**BAKERSFIELD CITY SCHOOL DISTRICT
ROOSEVELT ELEMENTARY SCHOOL MODERNIZATION
BAKERSFIELD, KERN COUNTY, CALIFORNIA**

Job No. 1317
Appl. No. 15-6
File No. 03-122920

ADDENDUM NO. #02

NOTICE TO CONTRACTORS FIGURING THIS WORK

PARTIAL ELECTRICAL SITE PLAN

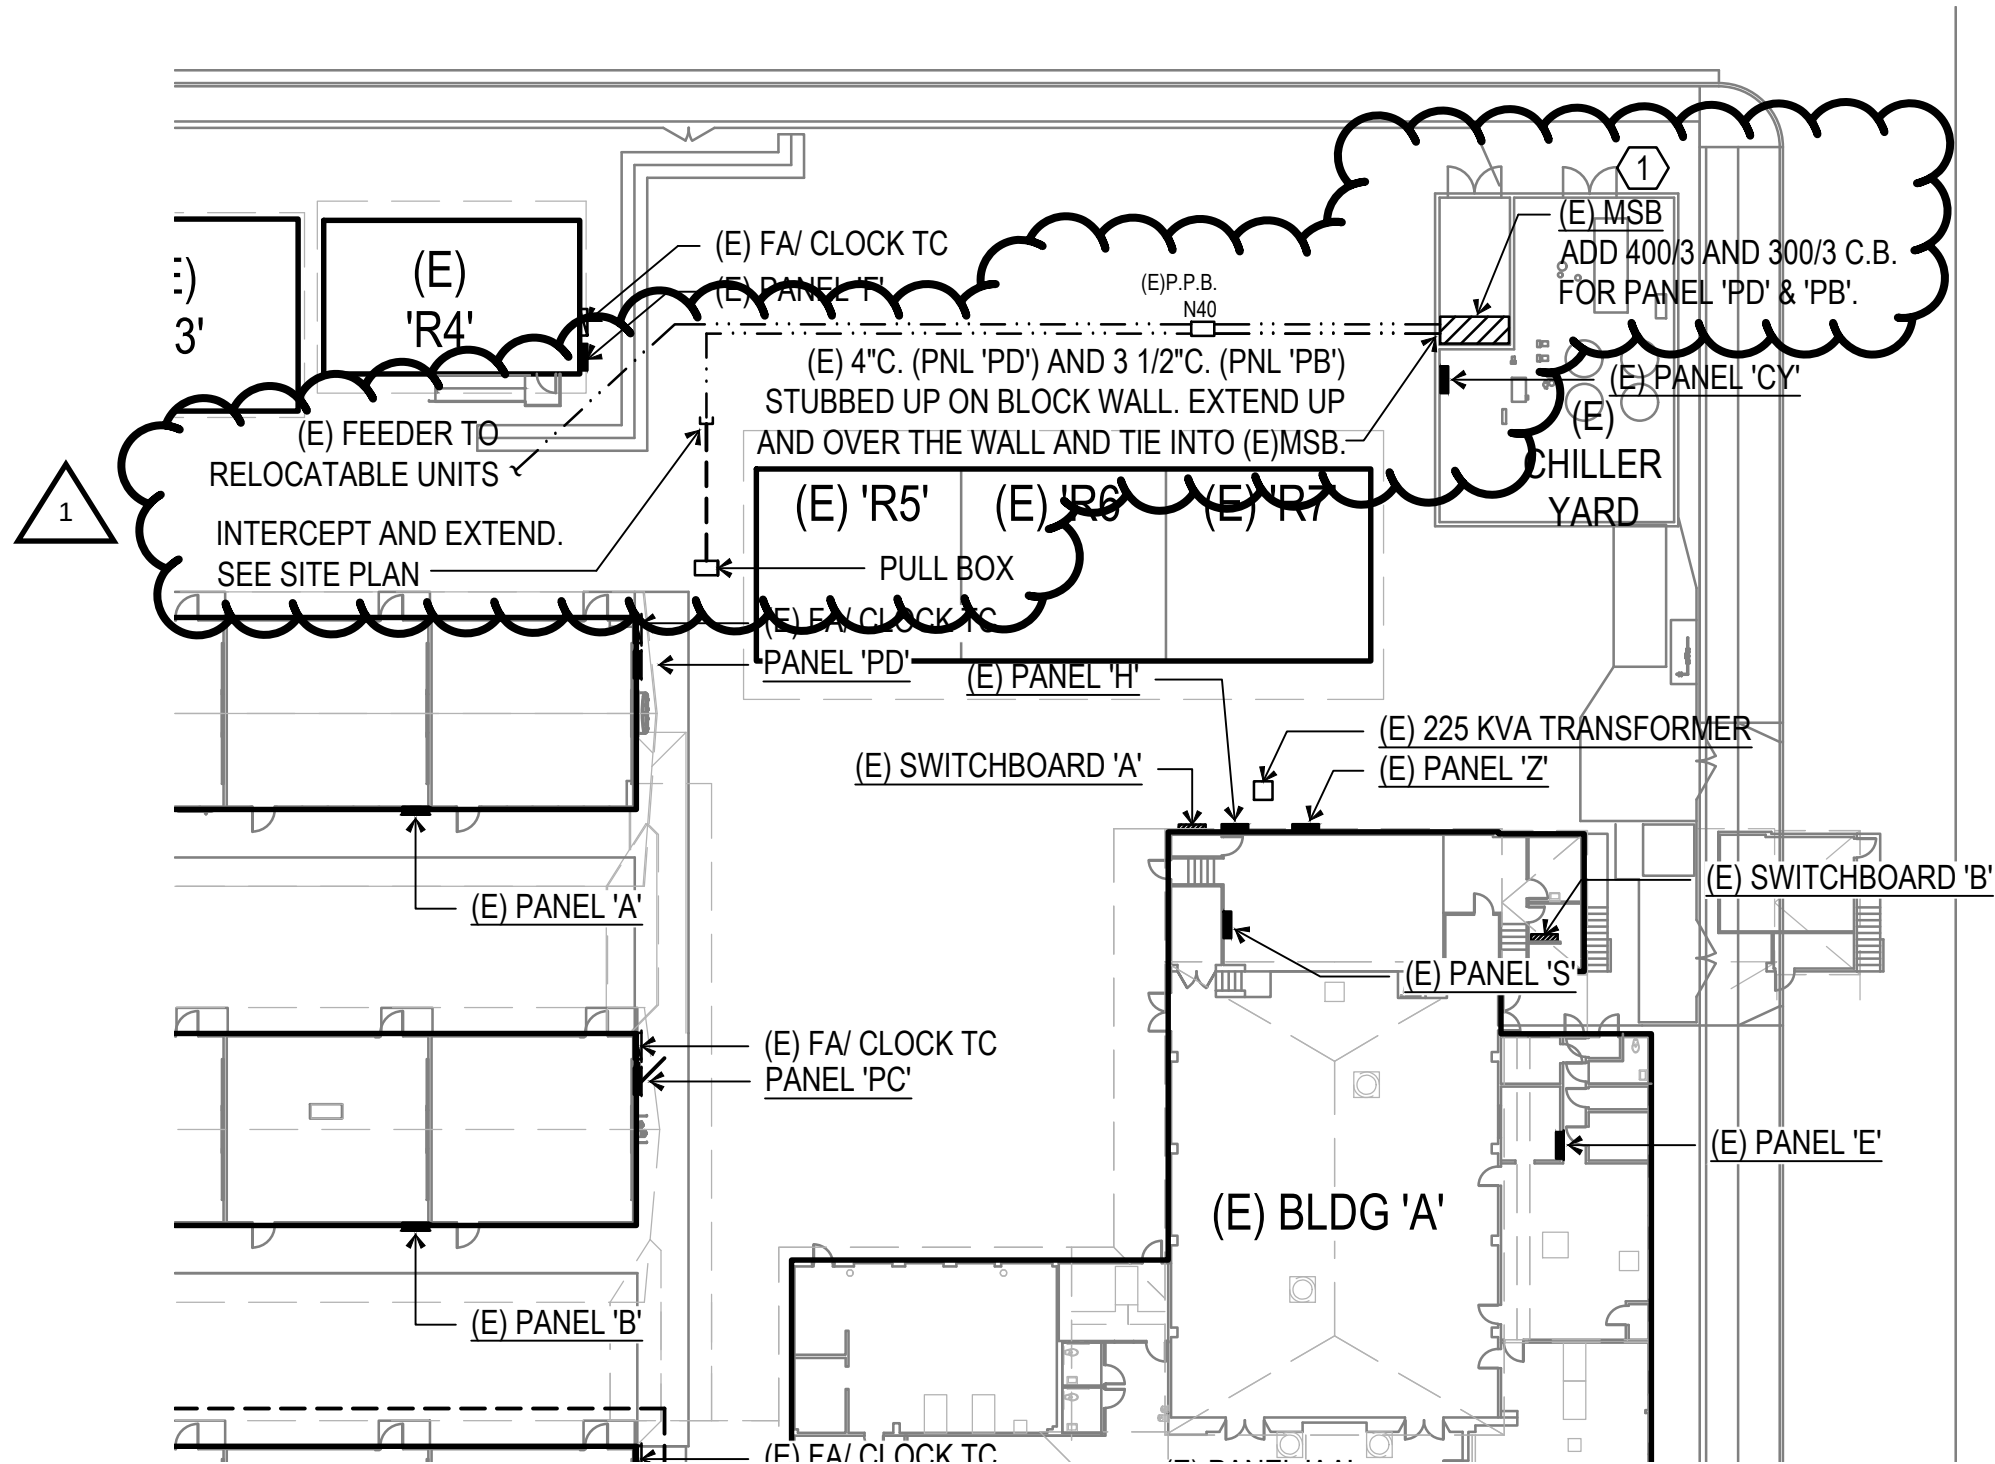
- 2-17) Refer to DSA Approved Drawings, Sheet No. E1.00 ELECTRICAL SITE PLAN, SYMBOL LEGEND, DETAILS AND NOTES,
- a. ADD: An existing 4”c for PNL PD and an existing 3.1/2” c for PNL PB are currently stubbed above grade on the face of the existing block wall that houses the existing MSB. Contractor shall extend conduits and go up and over the wall and tie into the existing MSB to provide temp power to the buildings for the modernization and add breakers to the existing MSB as indicated per attached Drawing No 09.

- a. Add: Install the District provided MSB (next summer). This will include the demo of the existing MSB, demo of the “temp” conduits as mentioned in item 2-17a. Providing and installing conduits from pull box N40 to the MSB, which includes boring under the existing footing of the block wall, PG&E coordination and energizing.

- 1 EXISTING MSB TO BE REPLACED SUMMER OF 2025. DISCONNECT TEMPORARY PANEL 'PD' AND 'PB' FEEDERS. INTERCEPT AND EXTEND 4" C AND 3 1/2" C FROM EXISTING N40 P.B. BORE UNDER EXISTING BLOCK WALL FOOTING TO NEW MSB.

PARTIAL REFLECTED CEILING PLAN BUILDING 'A'

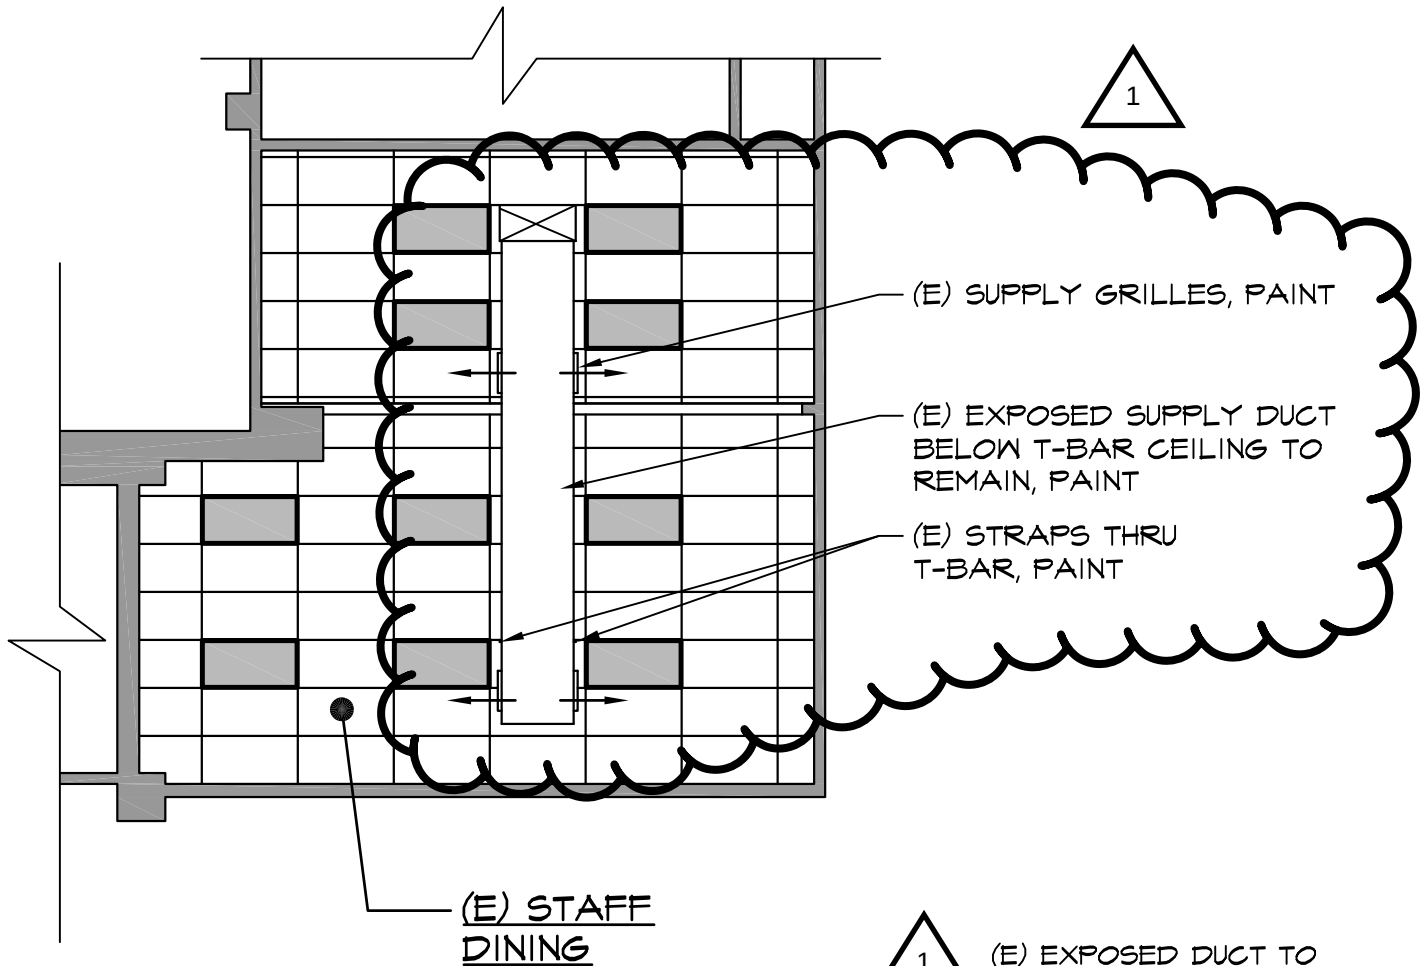
- a. ADD: Existing field discovered exposed duct work as indicated per attached Drawing No. 10. Duct work shall stay in place and be protected during construction, all scheduled work shall work around the existing duct work. Clean all registers and paint all portions of the exposed ductwork.

1 (E) EXPOSED DUCT TO REMAIN

ITEM • 2-15a
REF. DSA APPROVED
DRAWING, SHEET A1.0

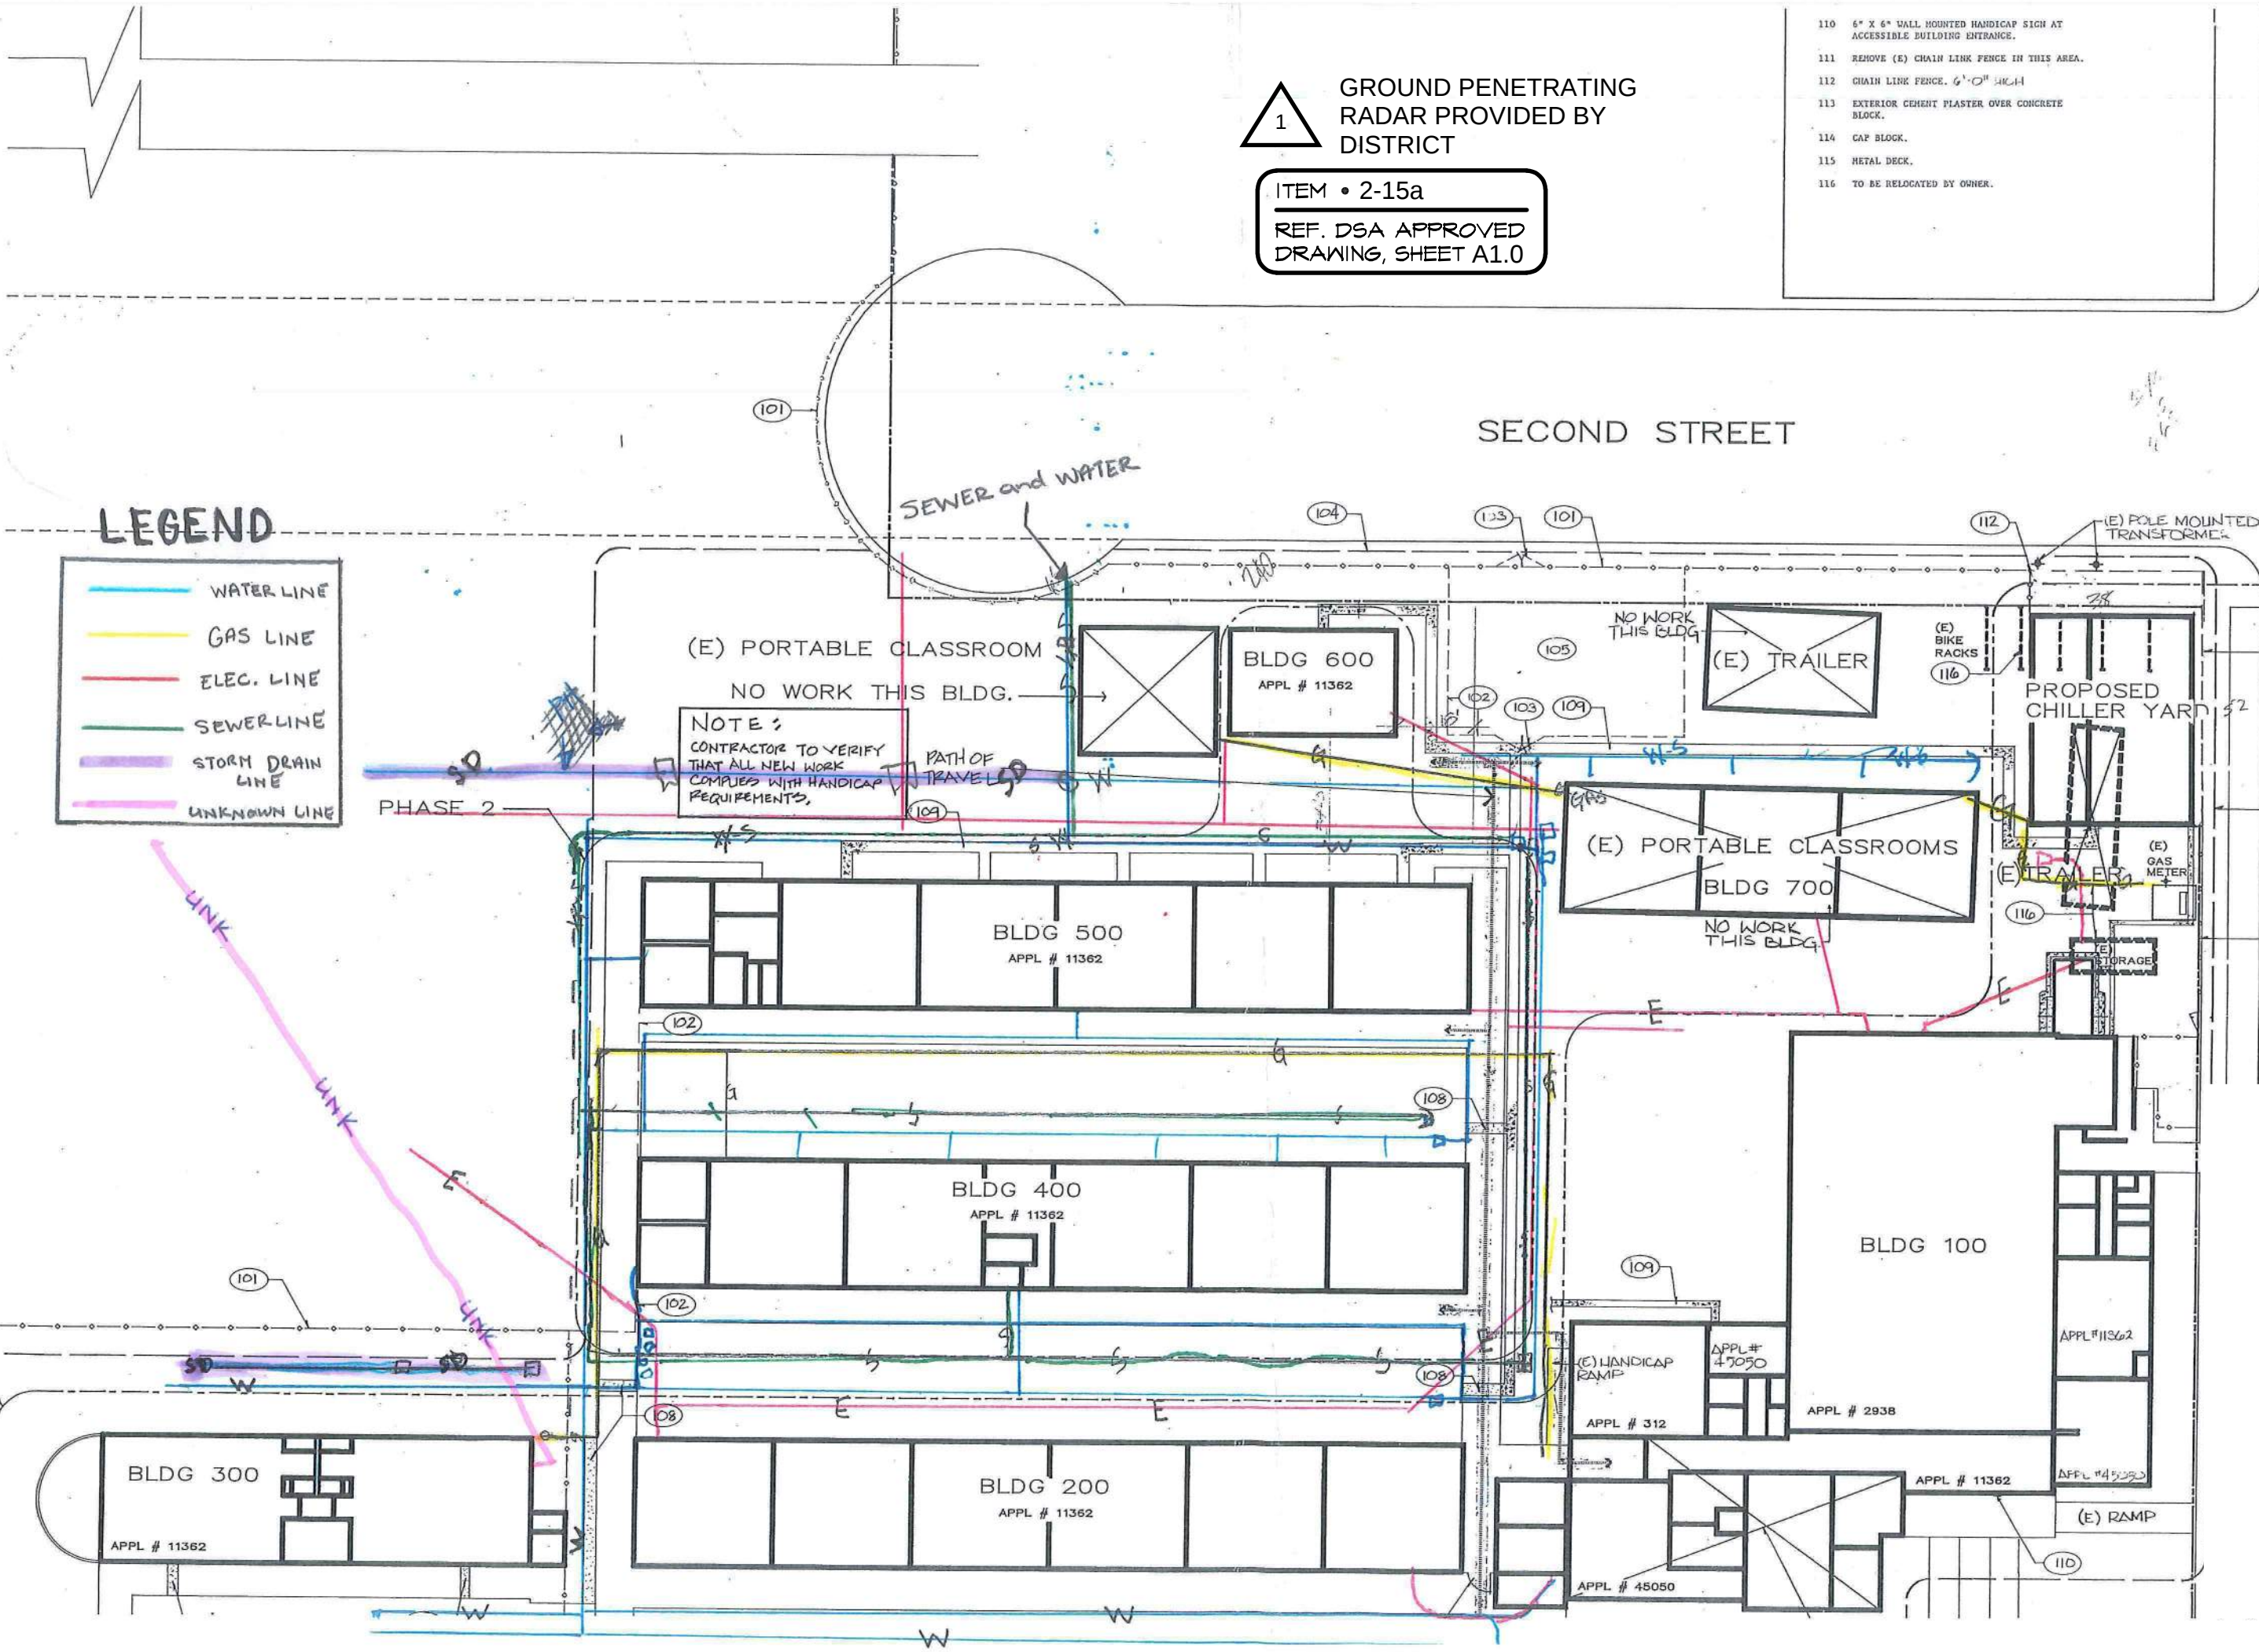
- 2-15) Refer to DSA Approved Drawings, Sheet No. A1.0 SITE PLAN;
- a. ADD: Ground Penetrating Radar as provided by District as indicated per attached Drawing No. 11.

GROUND PENETRATING
RADAR PROVIDED BY
DISTRICT
